PLAN SHOWING PROPOSED
BUILDING ON
PLOTS Nos 88A, 88B & 107 SHEET B-1
SERAI QR
SCALE 8"=1'

MUNICIPAL HEALTH OFFICER'S REPORT.

LAND SURVEYOR'S REPORT.

BUILDING SURVEYOR'S REPORT.

PLAN OF GROUND FLOOR

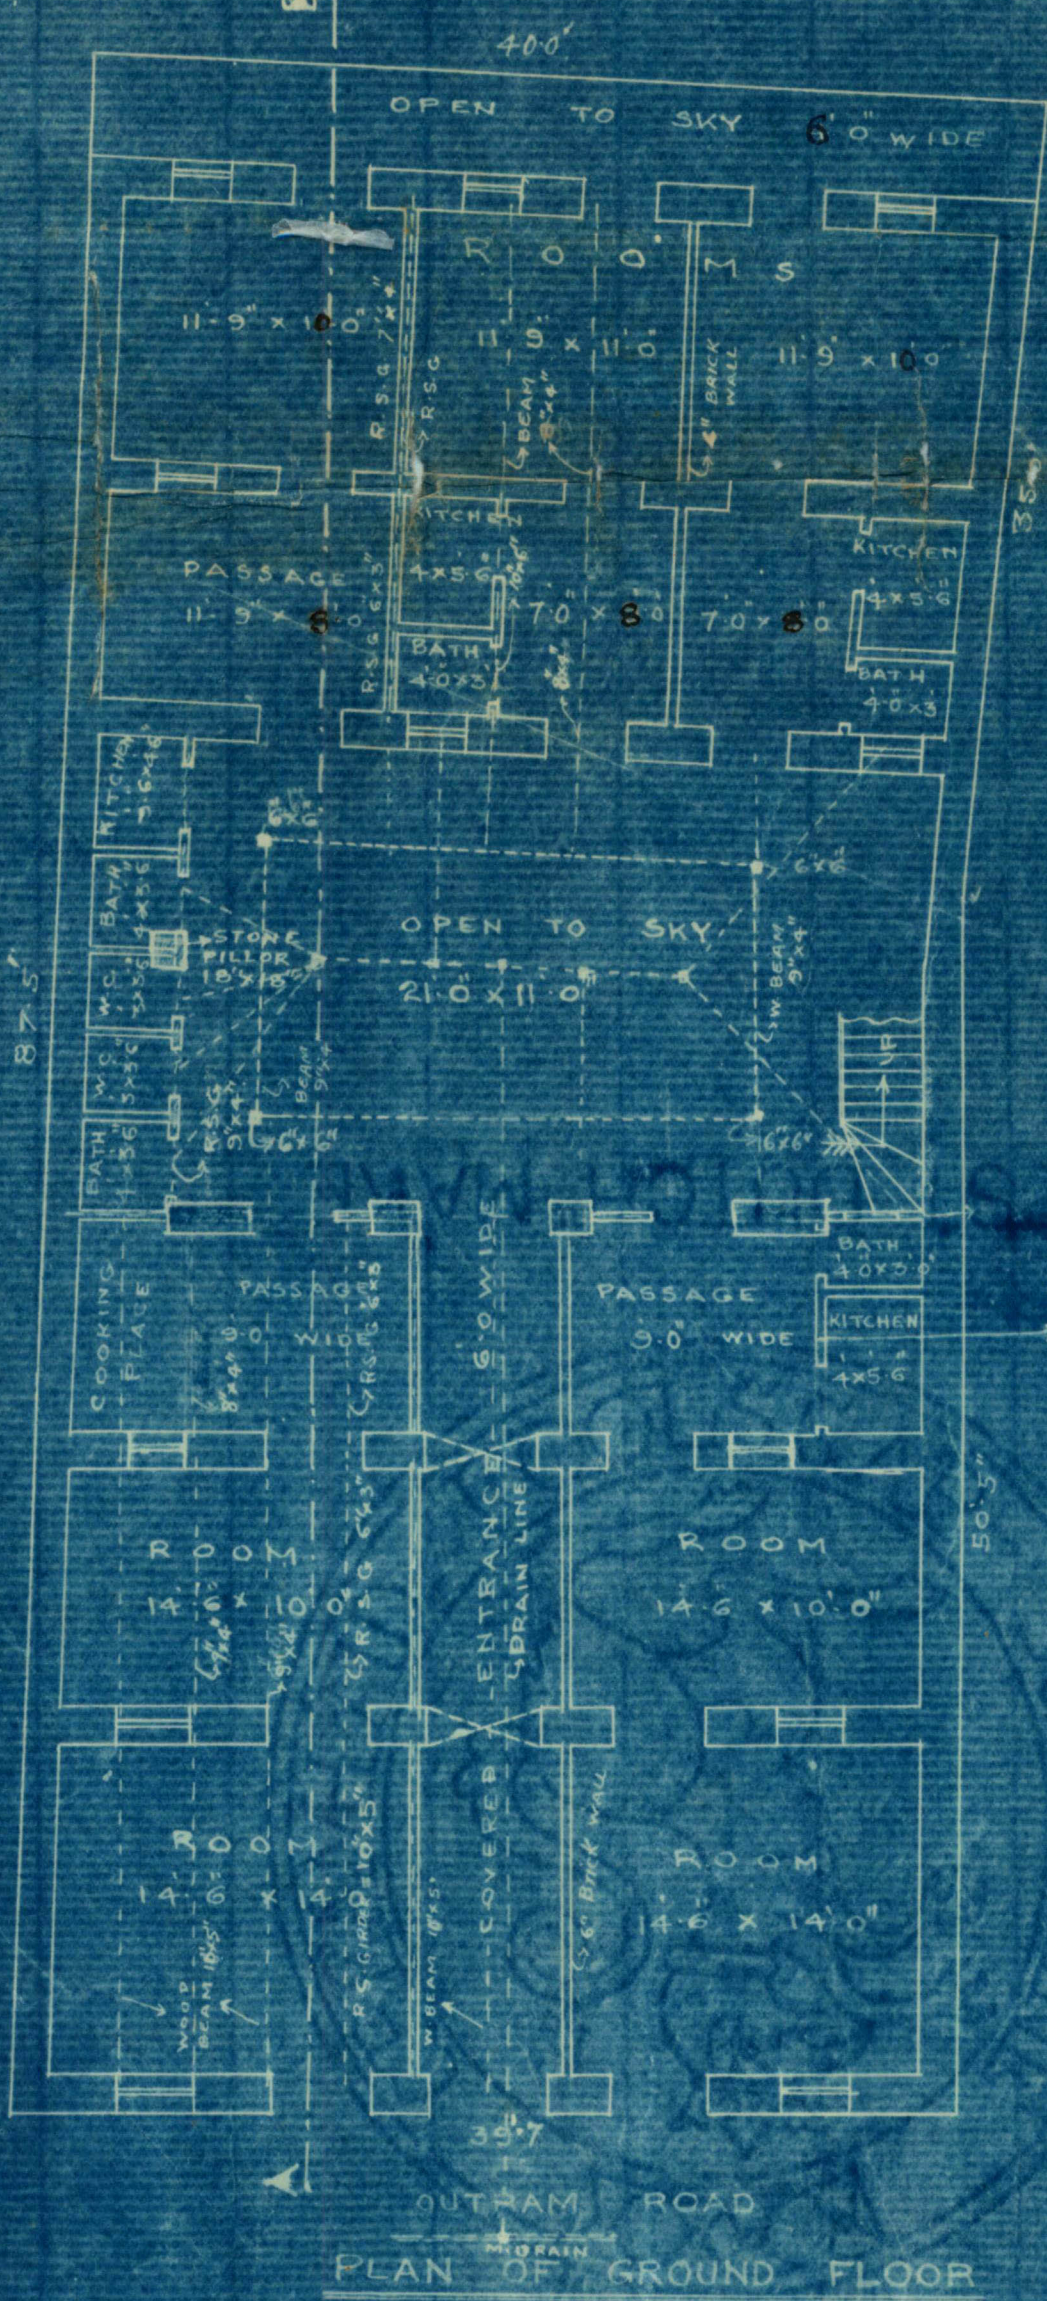
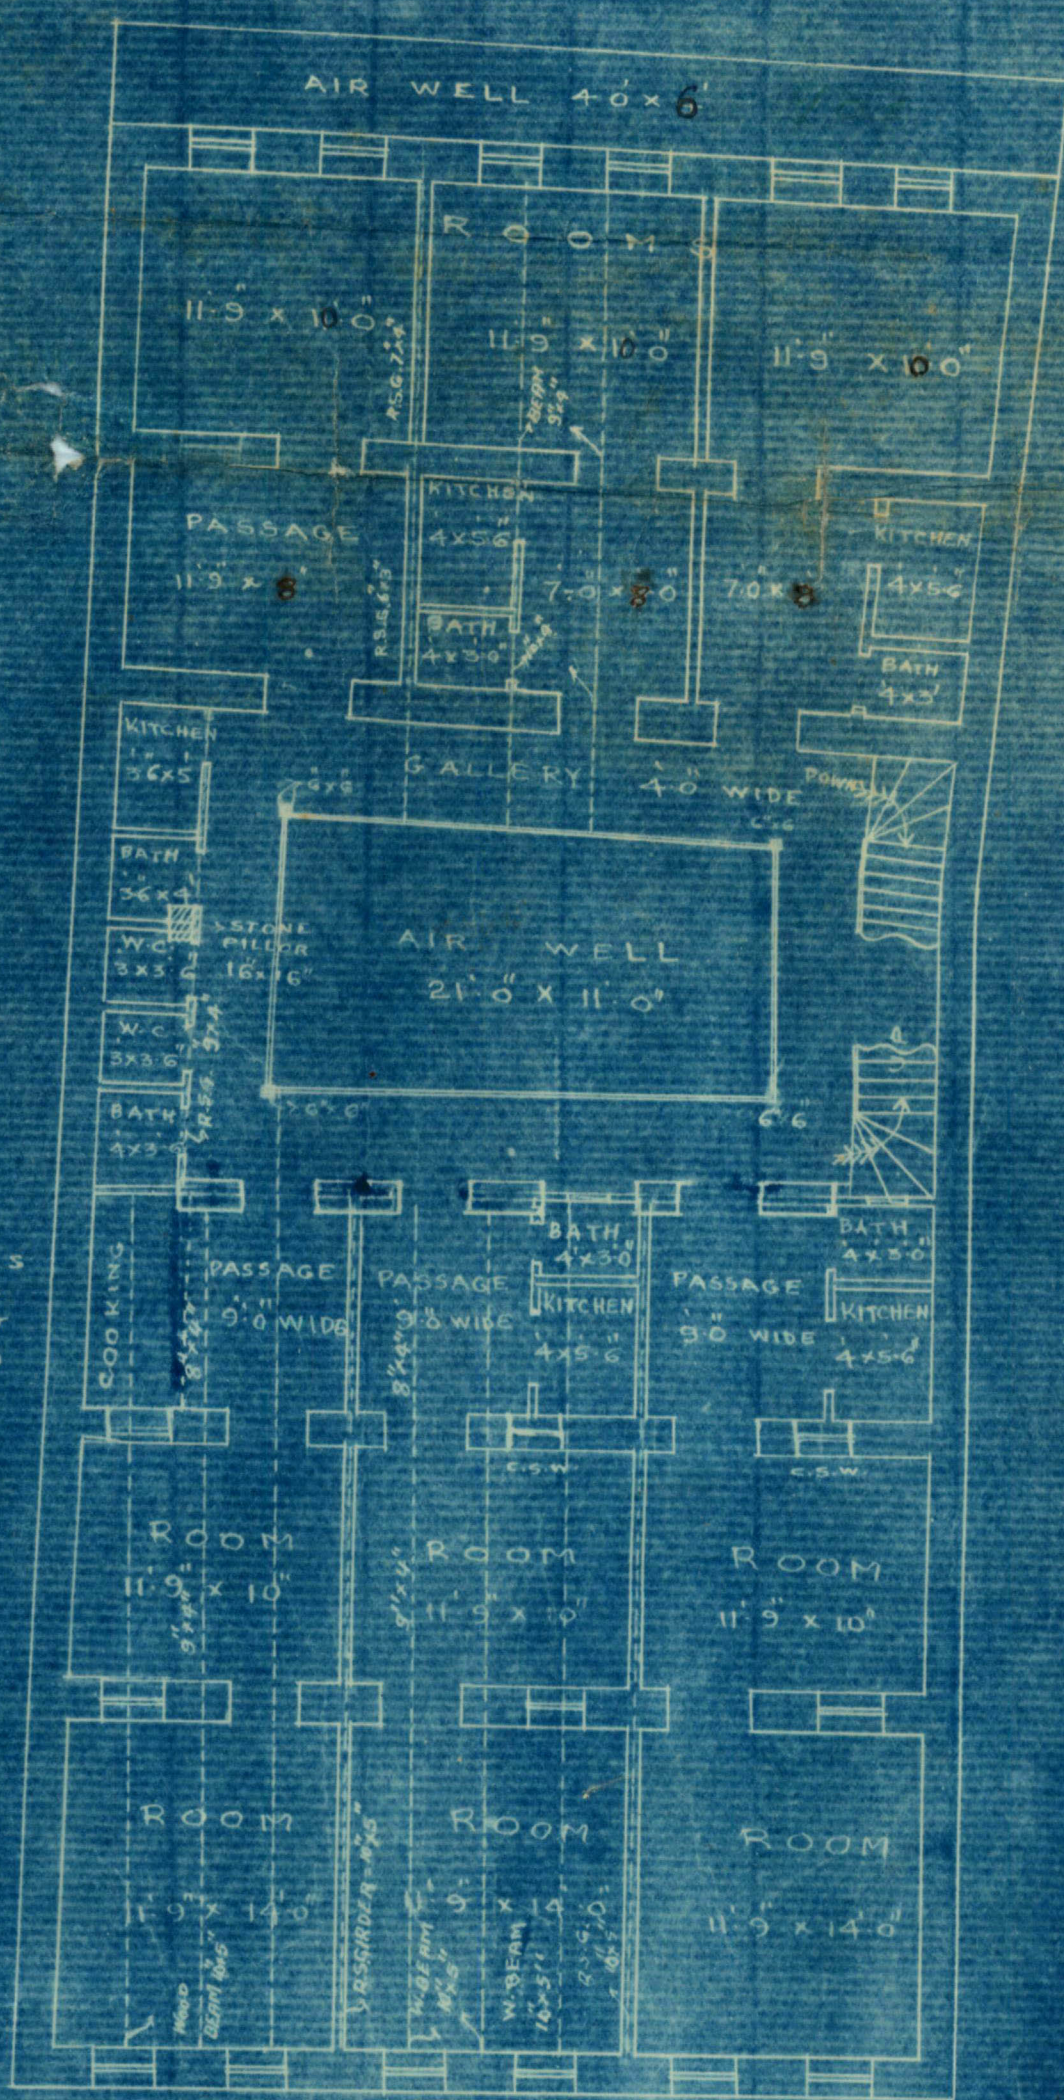
Br's doors + kitchen walls should be
7' & the front is about 5 1/2' to be fixed, windows
must be provided to the middle doors & ventilating
for rear rooms to allow cross ventilation
arrangement of pots should show a plan, pots
must be provided as shown on one of the blue prints

1. Outer wall should be built pucca
2. 12' x 7' beam should be provided below p. wall, 14 feet long.
3. ^{16' x 9'} beam must be provided below bath & w.c. p. walls.
4. Middle room will be dark
5. width of road should be 3'.
6. width of ground should be increased to 3' 6"
7. There will be no light in kitchen
